Docket Items # 10 & 11 BAR CASE # 2015-0039/0040

BAR Meeting March 18, 2015

ISSUE: Permit to Demolish (shed) and New Construction and Waiver of HVAC

LOCATION: 533 North Columbus Street

PROPOSED WEST ELEVATION

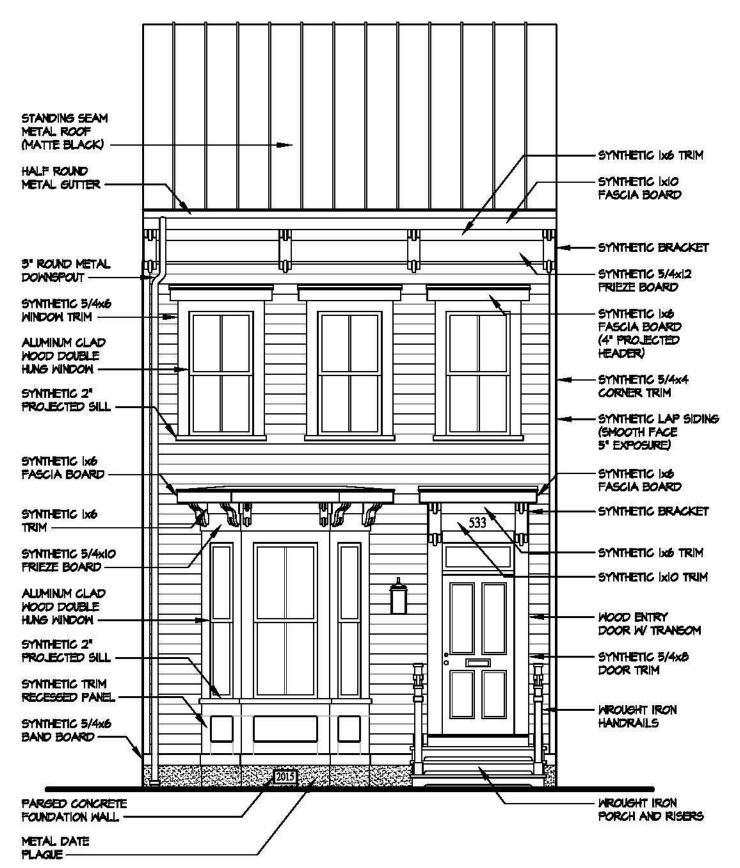
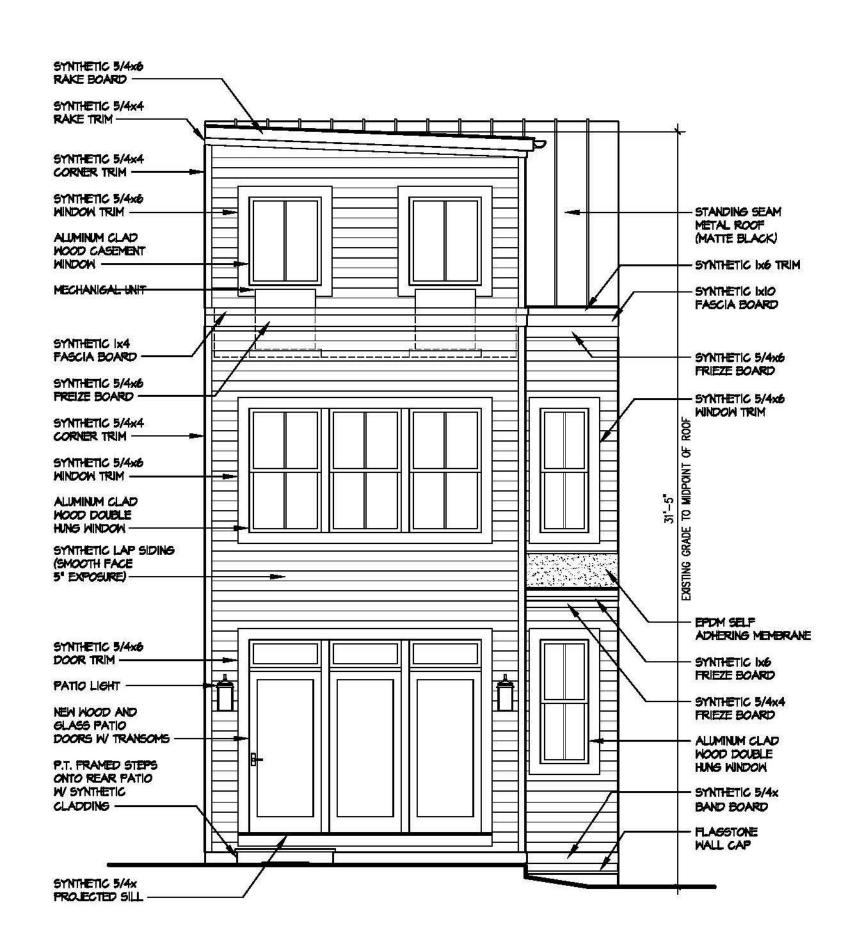
- 1. The new windows comply with the Board's Window Policy;
- 2. The window headers on the first floor be replaced with a smaller header to be approved by staff;

The front elevation of the house will have a first floor bay window with a pronounced cornice and decorative brackets. The four-panel wood door will also have a deep overhang with a glass transom and solid panel where the house numbers will be installed. The front stoop, stairs and railings will be constructed of wrought iron. On the second floor, there will be three, two-over-two double-hung windows. The cornice will have the same brackets that are on the bay window and door overhang.

3 PROPOSED EAST ELEVATION
A2 SCALE: 1/4" = 1'-0"

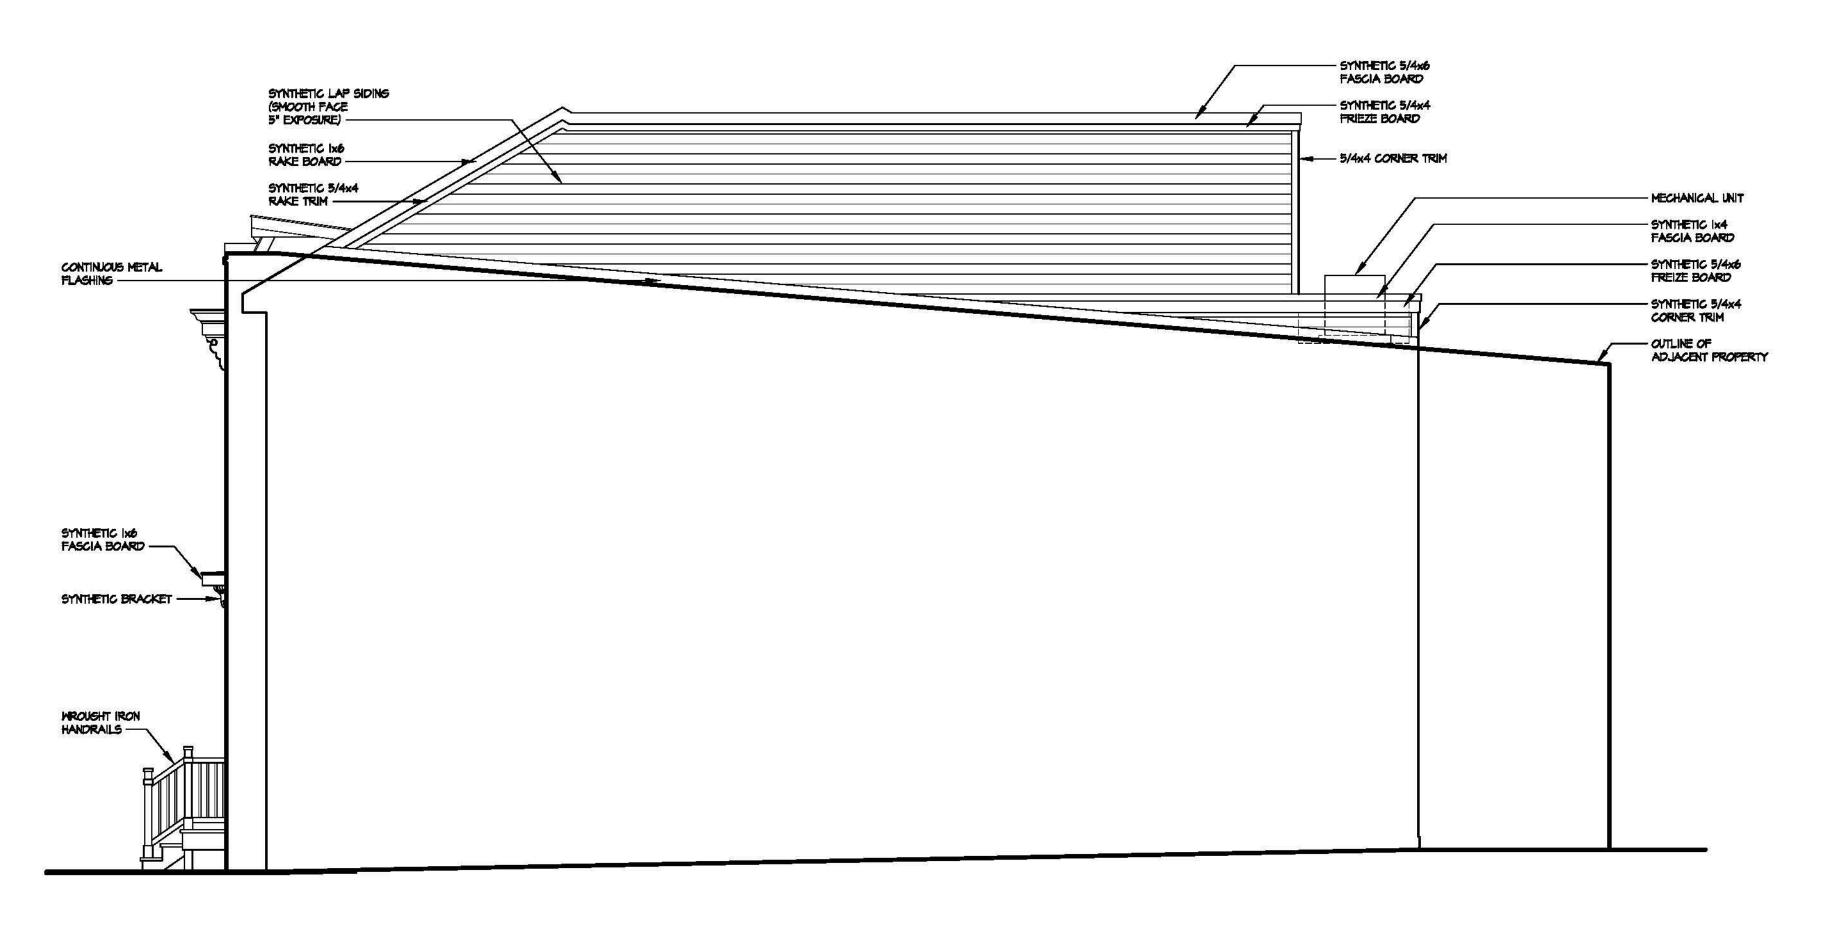
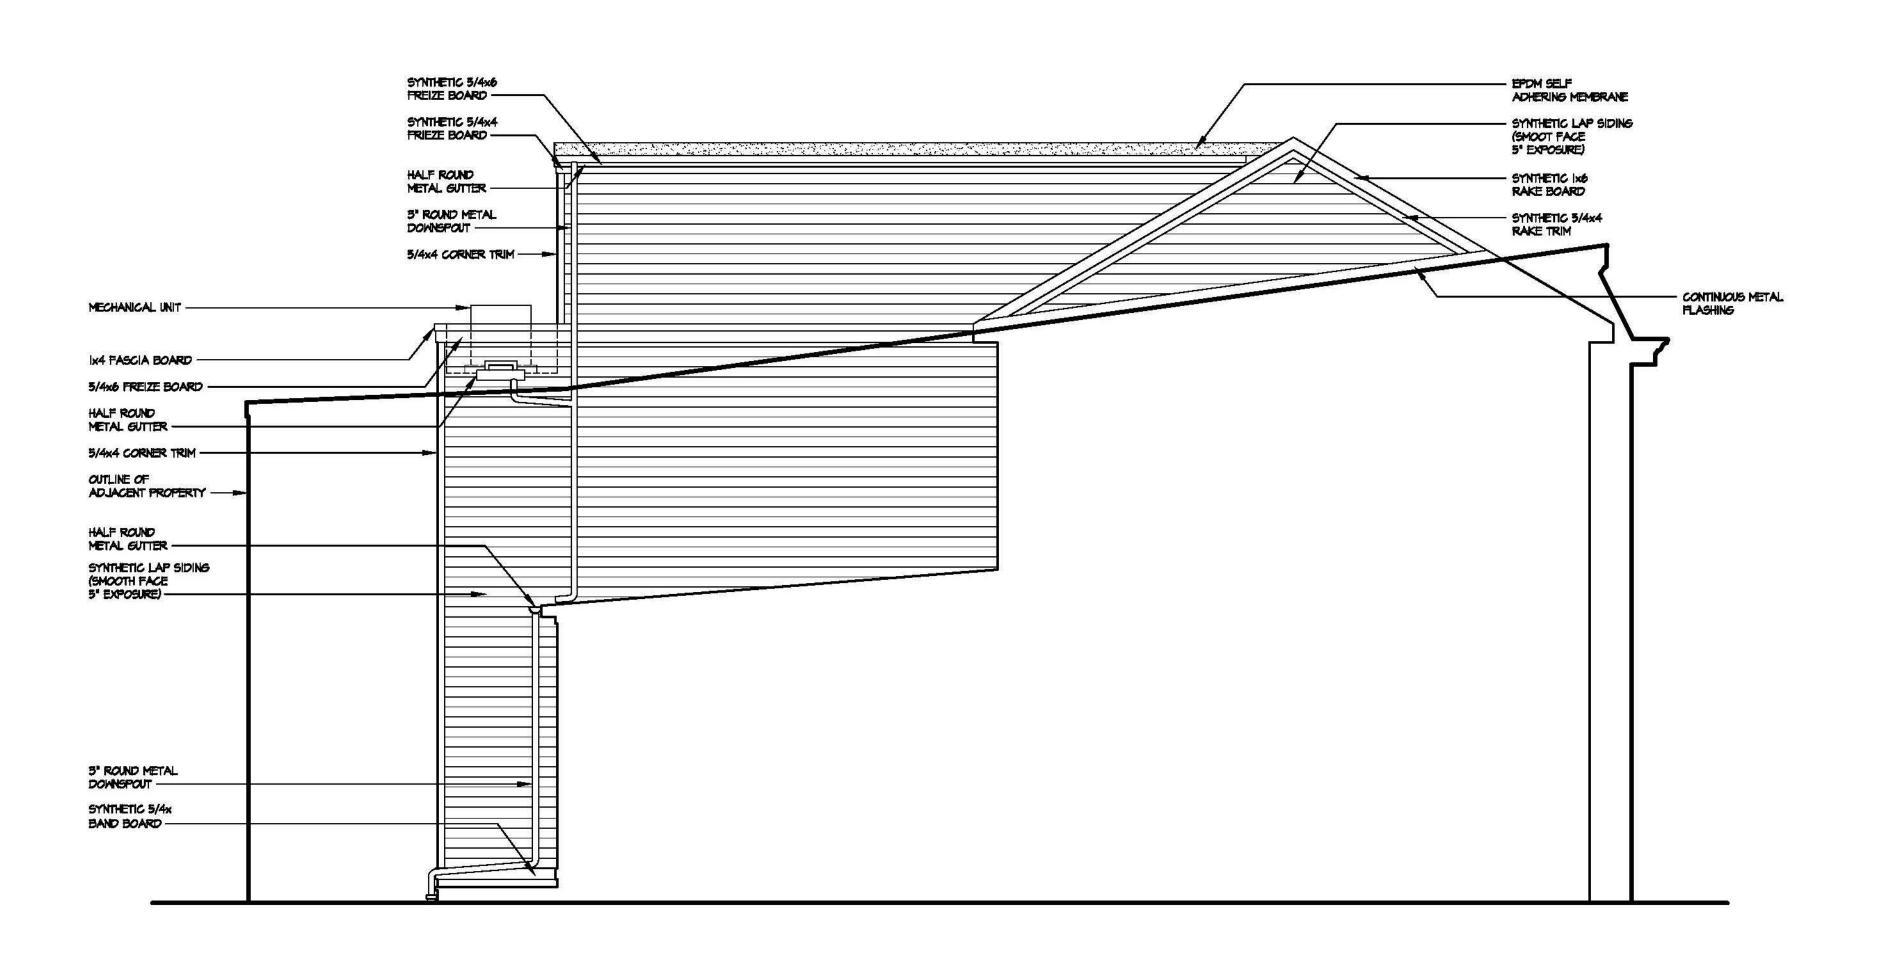
The proposed three-story frame house at 533 North Columbus Street will measure 17.5' wide by 48' deep and will be located on the north and south property lines. The house will extend approximately 2' beyond the existing house at 531 North Columbus Street, while the house at 535 North Columbus Street will project roughly 8' beyond the new house. The applicant, who also owns the townhouse at 535 North Columbus Street, proposes to block some existing windows on the south elevation of the existing house to allow for the construction of the new house (BAR Case# 2015-0036 & 0037). The first floor bay window will be located on the front property line, while the majority of the façade will be setback approximately 2'. The house will have a flat roof beyond a front gable slope facing North Columbus Street. The northernmost rear bay will be inset in order to allow for the retention of some windows on the south elevation of 535 North Columbus Street. On the east elevation, the third floor will be set back 5' to create a balcony for the two rooftop HVAC condensers.

Section 6-403(B)(1) of the Zoning Ordinance requires the architectural screening of rooftop mechanical appurtenances throughout the City. However, the BAR "having jurisdiction of the matter may, after public hearing, waive or modify the screening requirement of Section 6-403(B)(1) if the board finds such requirement to be architecturally inappropriate." In the opinion of staff, the HVAC equipment will be minimally visible on the upper balcony due to the screening wall and the BAR should approve the waiver.
